Digital Answering Machine SAM PSB 2168 Version 2.0

Delta Sheet 05.97

Delta Sheet for Target Specification 03.97

This Delta Sheet states the differences between the chip version 2.0 and the chip version 2.1 as described by the Target Specification 03.97.

Figure 2 Connection of MC 145480 to PSB 2168 V2.0

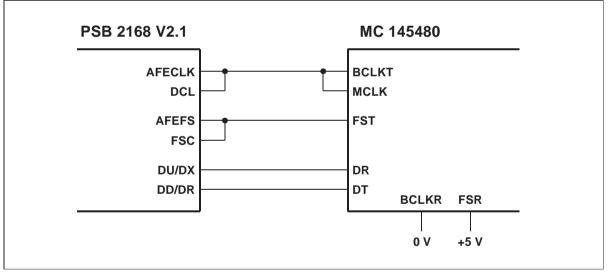
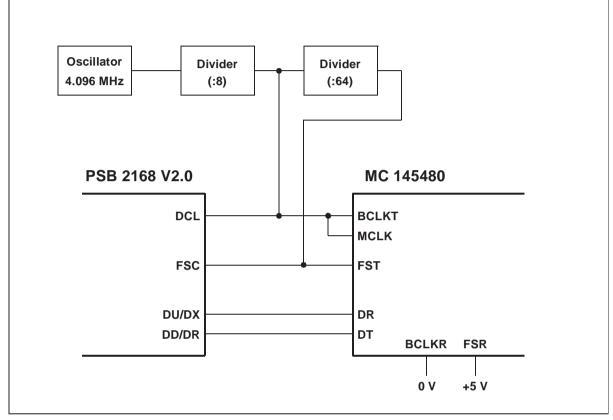
16 Auxiliary Clock Generation

The PSB 2168 V2.0 does not support auxiliary clock generation as described in chapter 2.3.9. Therefore the connection of a simple codec requires an external clock source.

As an example figure 1 shows the connection of an MC 145480 to the PSB 2168 V2.1 and figure 2 shows a workaround for the PSB 2168 V2.0.

The PSB 2168 V2.0 does not supply any clock at AFEFS of AFECLK. Therefore the synchronized clocks must be supplied by external circuitry as shown in figure 2.

In this example the PSB 2168 V2.1 generates the data clock (512 kHz) at AFECLK and the frame synchronization signal (8 kHz) at AFEFS. Both clocks are synchronized by the PSB 2168 V2.1. The MC 145480 is operated in General Circuit Interface mode (selected by BCLKR = 0 V). Data is transmitted and received in timeslot 2 (selected by FSR = +5 V) and double clock mode is used.
